Index 102-661 Bicycle Lane Closure

COMMENTARY

COMMENTS AND RESPONSES

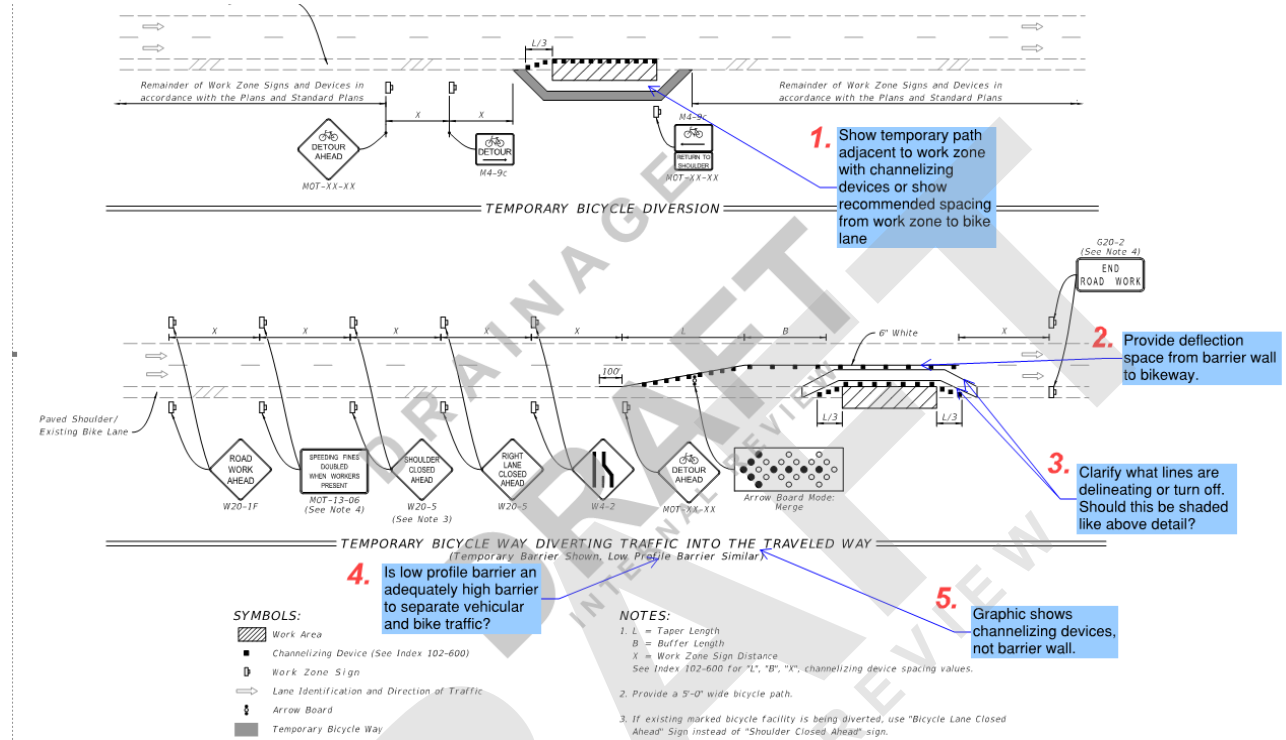
3. Sheet 2 of 2; layouts lack guidance on the geometry (transitions) for the bicycle diversion; likewise for diversion surface outside of the roadway. RAP material is unacceptable for both bike and occasional ped use. Temp pavement (misc asph) is recommended

RESPONSE: *The intent of the Index is to provide details for the appropriate signage and delineation of a bicycle diversion. However, it is acknowledged that additional guidance on acceptable transitions would be helpful. Options will be reviewed for future revisions. As for the acceptable materials used for the construction of the diversion, Specification 102 will be updated.*

Change Made: *Specification 102-6.8 will be updated to include Bicycle diversions.*

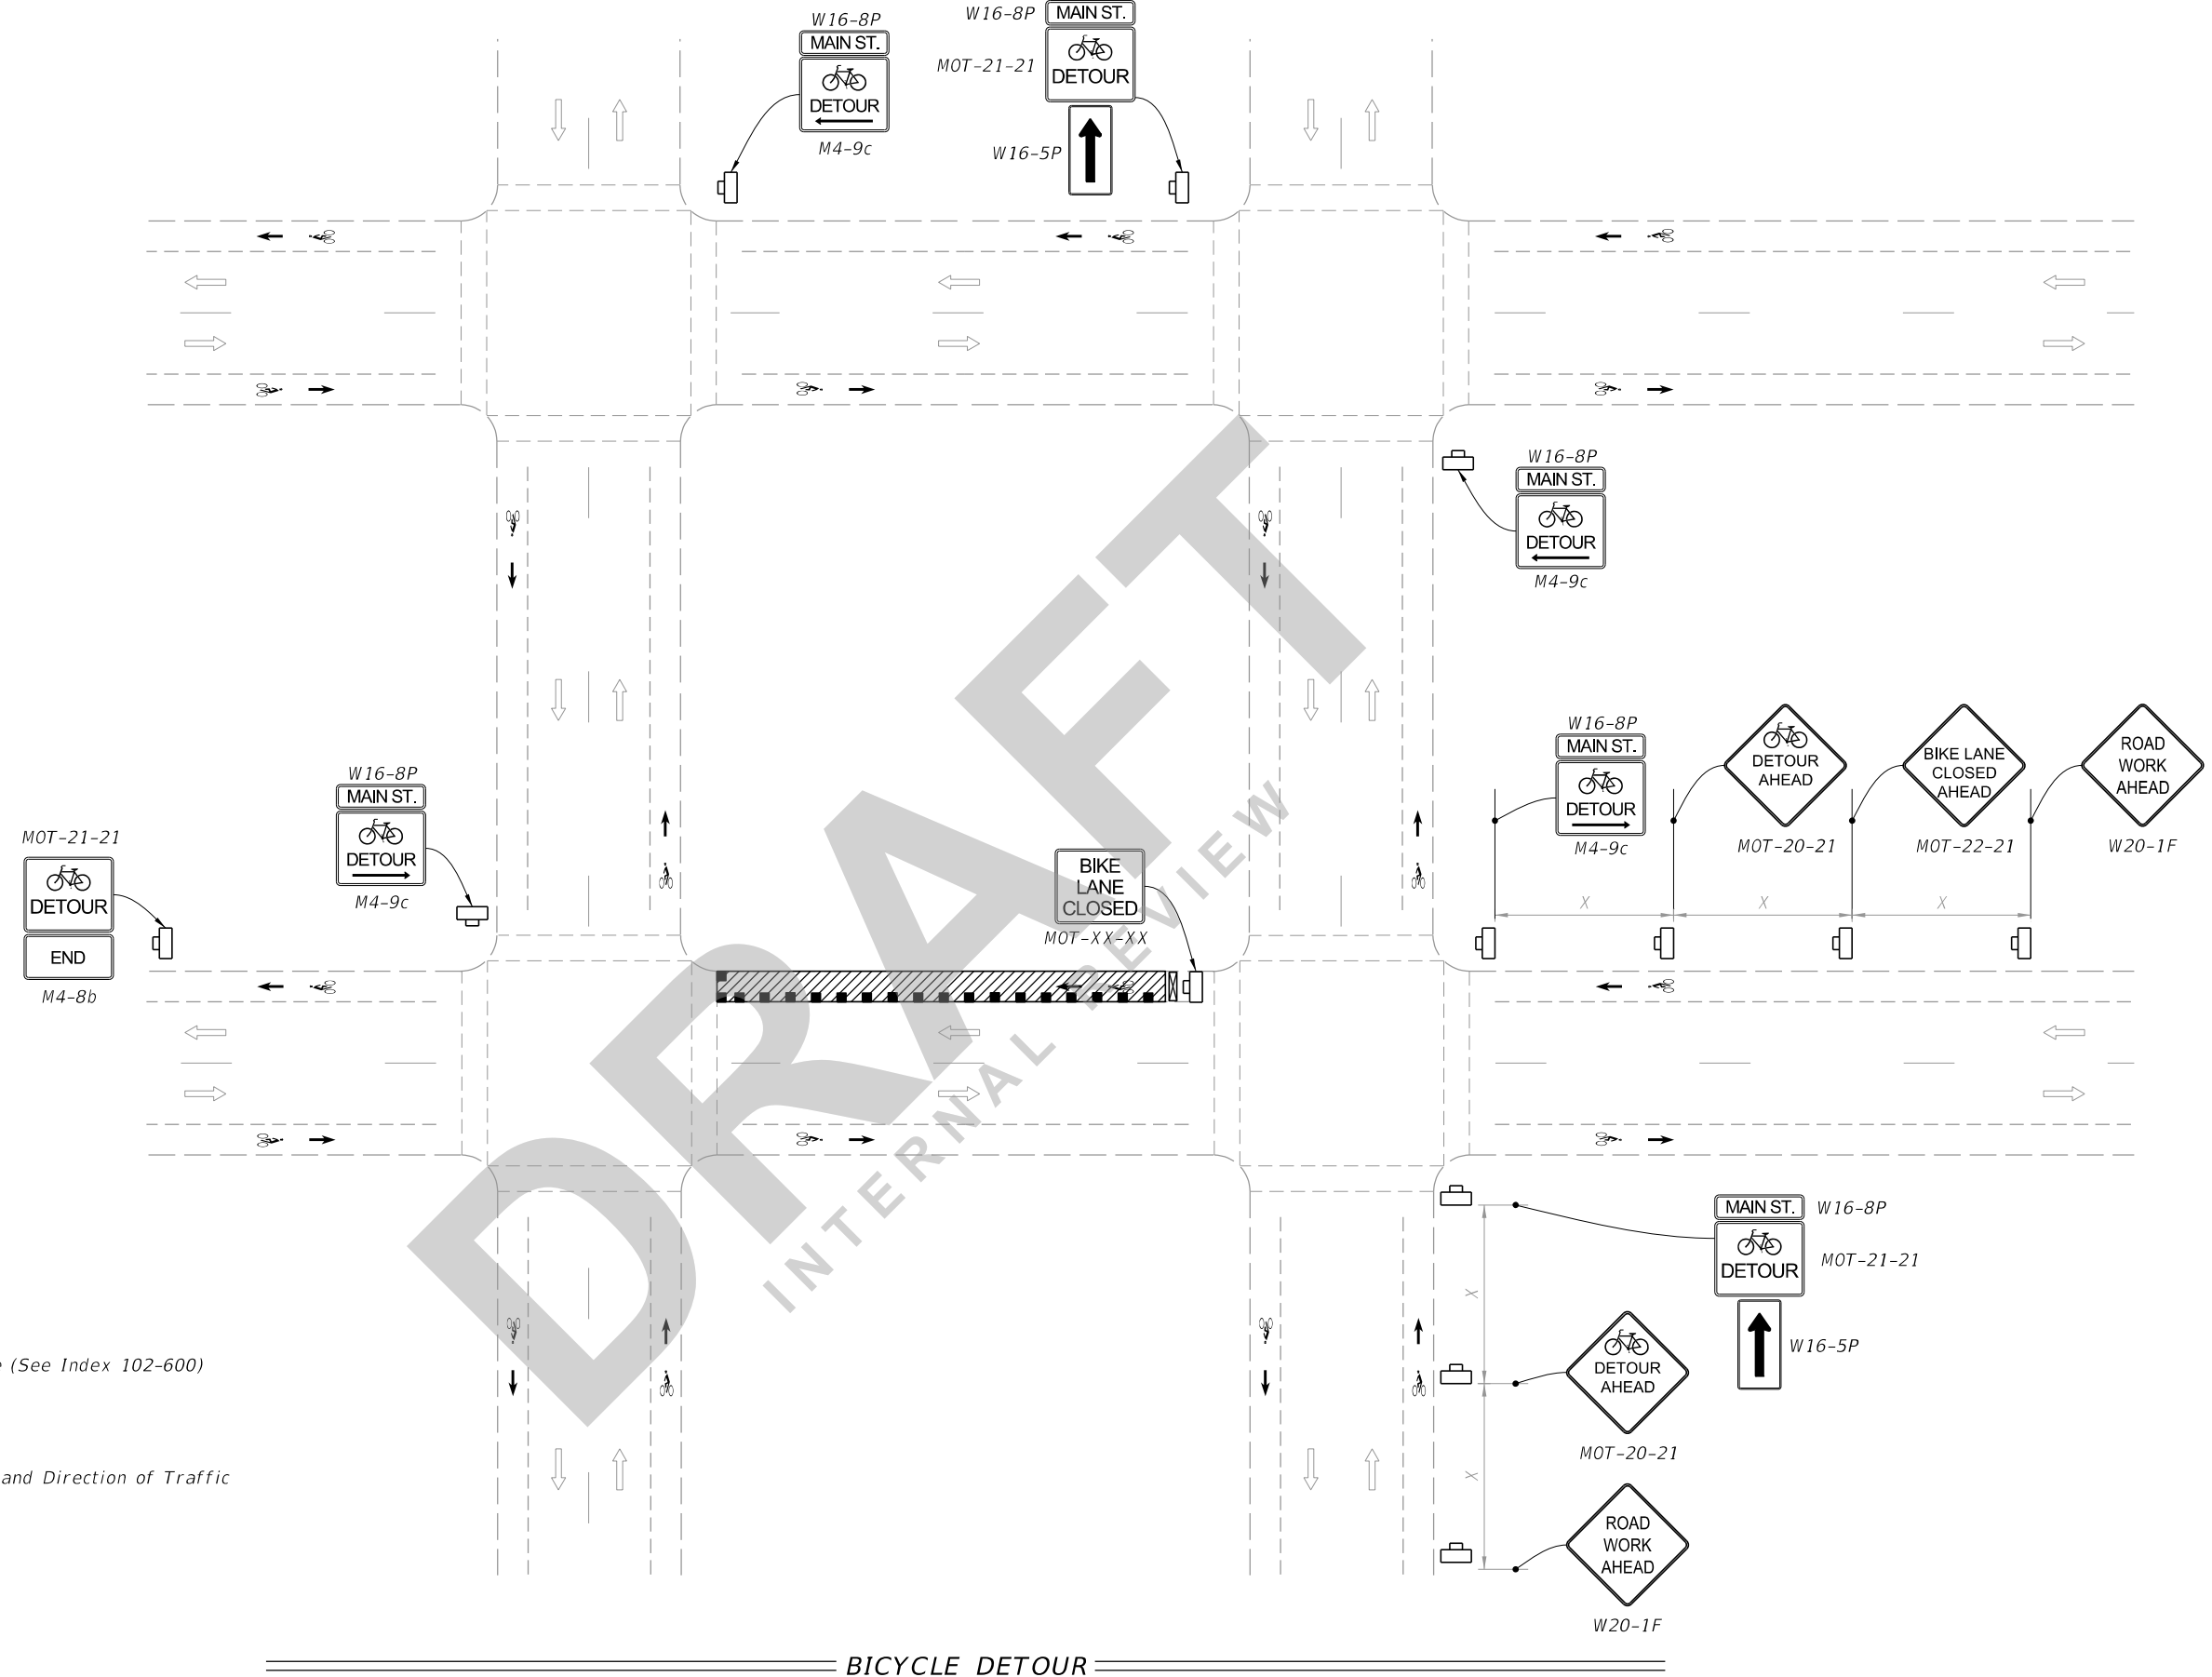
Name: Brad Salisbury
 Date: August 21, 2020

1. Agreed
Change Made: Channelizing devices will be added between work area and diversion.
2. Barrier is not required
No Change
3. Agreed
Change Made: Shaded the area.
4. The statement in parentheses should not be included and will be deleted.
Change Made: Statement in parentheses deleted.
5. The statement in parentheses should not be included and will be deleted.
Change Made: Statement in parentheses deleted.

LAST REVISION 11/01/20	REVISION	DESCRIPTION:		FY 2021-22 STANDARD PLANS	BICYCLE LANE CLOSURES	INDEX 102-661	SHEET 2 of 2
---------------------------	----------	--------------	--	------------------------------	-----------------------	------------------	-----------------

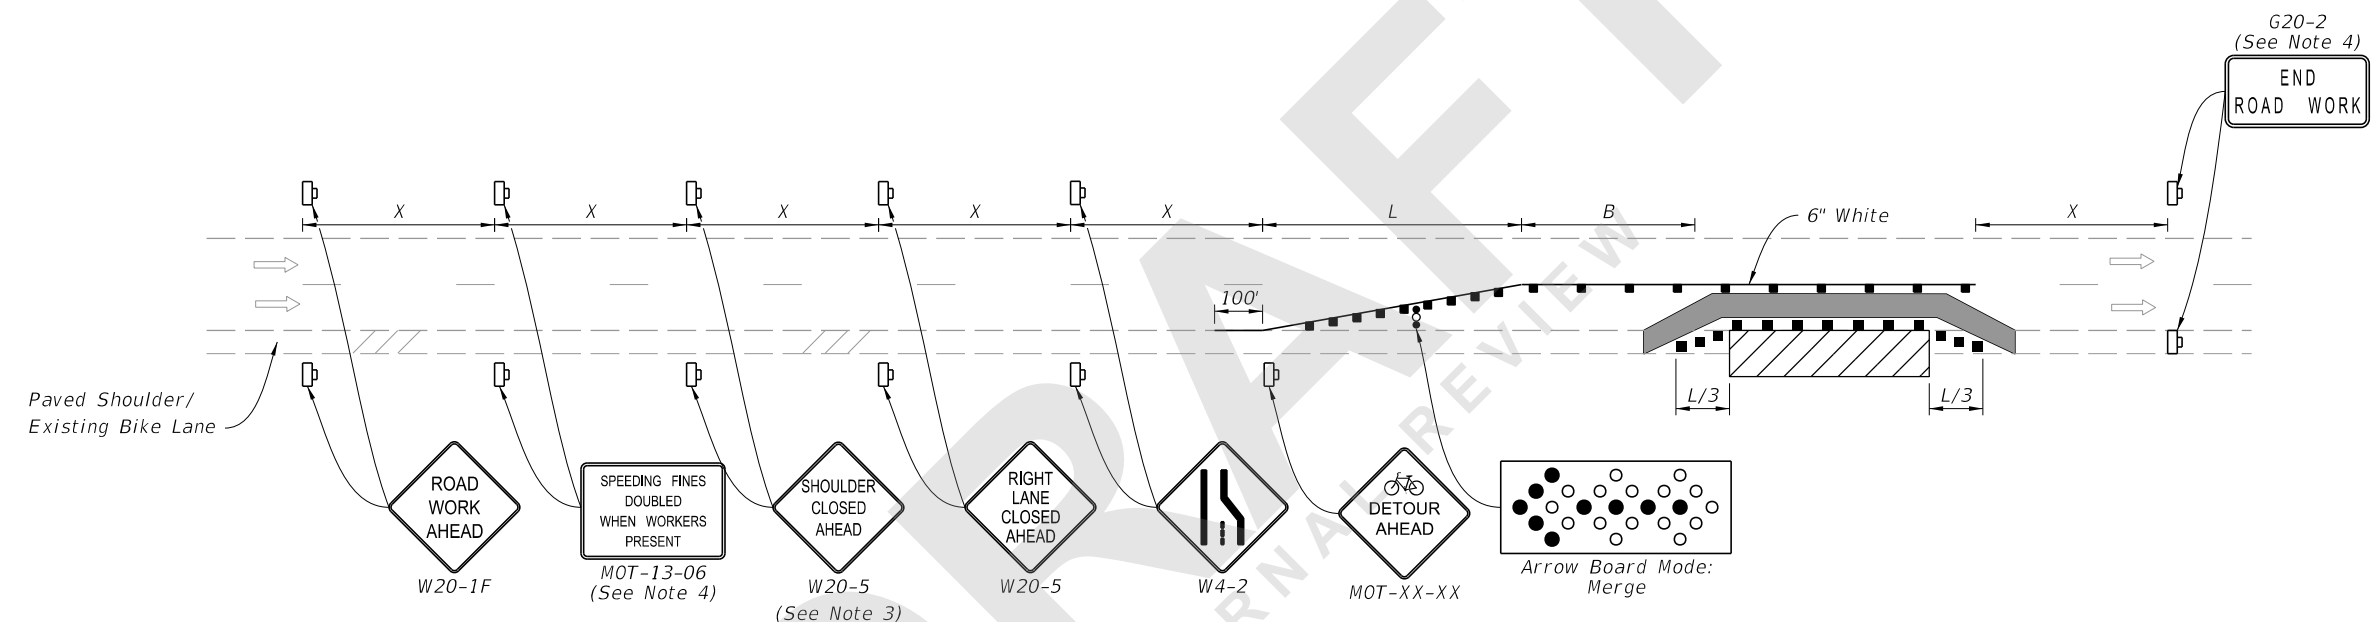
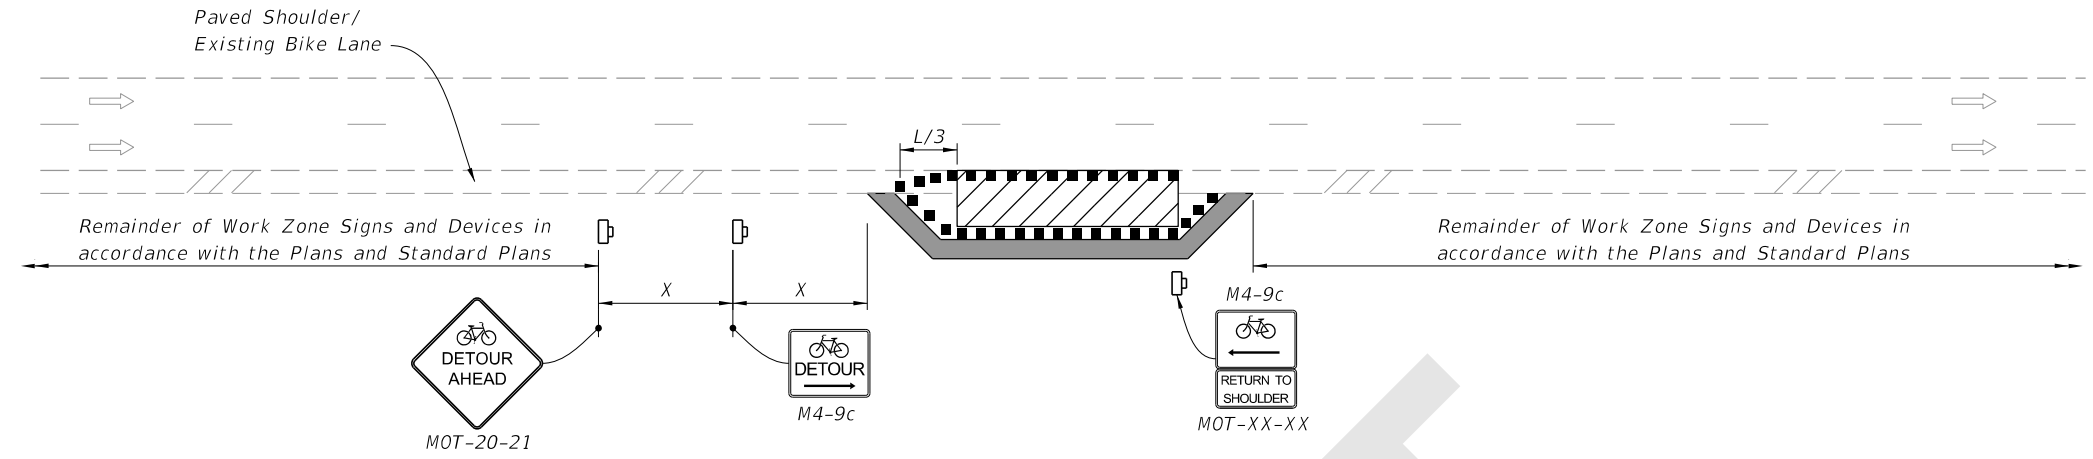
COMMENT: Sheet 2: Where is info of acceptable materials to construct a temp bike diversion?

1. Sheet 2: How will temporary path for bike facility be paid for and quantified? Will this be similar to pedestrian special detours?

2. Sheet 2, Bottom Figure Label: Parentheses indicate temp. barrier is utilized. However, no barriers are shown within figures or legend. Only LCD's are shown.

3. Sheet 2: Consider additional note to specify project-specific designs when diversion into closed travel lane is incorporated near or through intersections. Possible cyclists could be overlooked by vehicles attempting to navigate across the intersection.

RESPONSE: *Agreed. This will be addressed in Specification 102.*

Change Made: *Specification 102-6.8 will be updated to include Bicycle diversions.*

RESPONSE: *The Pedestrian Detour item will be updated to include both Bicyclist and Pedestrians facilities.*

RESPONSE: *The statement in parentheses should not be included. Temporary barrier is not required. Please note that LCD's are not required either.*

Change Made: *Statement in parentheses deleted.*

RESPONSE: *Agreed.*

Change Made: *Note added: "5. Included additional signage at intersections as required by the Engineer or shown in the Plans".*
